# BOA-20-10300013 - 335 Trail

**Application Name:** [335 Trail](#)

The Applicant, John Hertz of Bexar County, alleges that the following administrative official Shanon Miller in her capacity as Historic Preservation Officer made an incorrect decision, or interpretation regarding Section 35-\_\_\_\_\_ of the UDC. This incorrect decision or interpretation was (List the section(s) of the UDC that was applied incorrectly. Provide details why the decision was incorrect or misinterpreted.): Incorrect decisions or interpretations regarding numerous UDC sections were made as set out on Attachment "A", and its exhibits.

Stormwater Management as shown in application for CoA

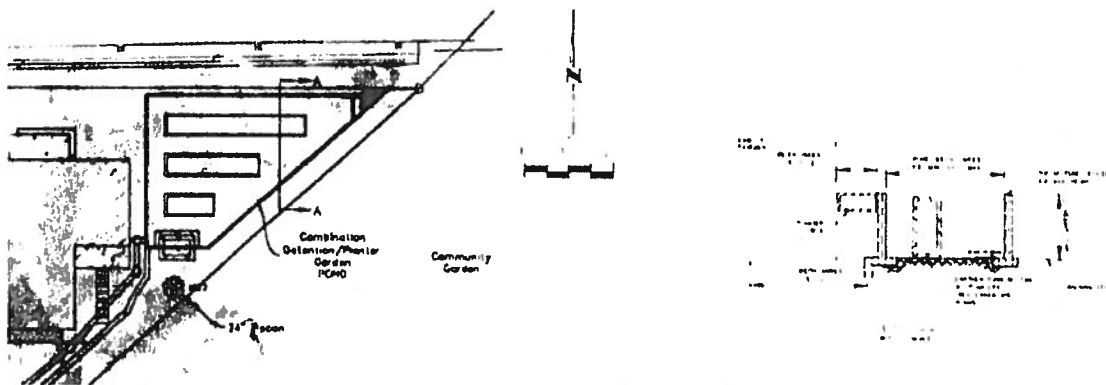
An incorrect decision or interpretation was made regarding UDC §35-673(c) that section requires that storm water features be multi-purpose. As set out in more detail on the attached Exhibit "1" and as demonstrated by the documents submitted to the HDRC, the proposed project utilizes a landscaped open basin does not meet the multi-purpose requirement.

The proposed project utilizes what is in effect a landscaped open basin that is not multi-purpose as the UDC envisions. The proposal can be seen in the project submittal of Dec. 18, 2019.

Compromised  
Heritage Tree:  
Construction Within 7  
feet of the tree trunk

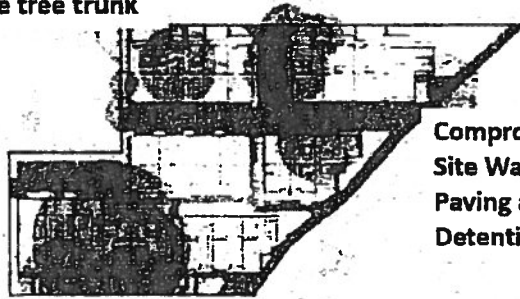
The proposed project's site design shows the removal of all but 4 trees on the site. These trees are shown on the plans as "Preserved", even though buildings are shown within 6 or 8 feet of large trees, trenches and walls are shown to extend through the tree Root protection Zones. Trees will be compromised severely by construction and over a foot of fill material placed over the Root Protection Zone, according to the grading plans for the project.

Trees shown to "remain" ... ALL are severely compromised by the site design.

Compromised Heritage Tree  
Site Wall Through Root Zone,  
Paving around Base of Tree, and a  
Detention Pond
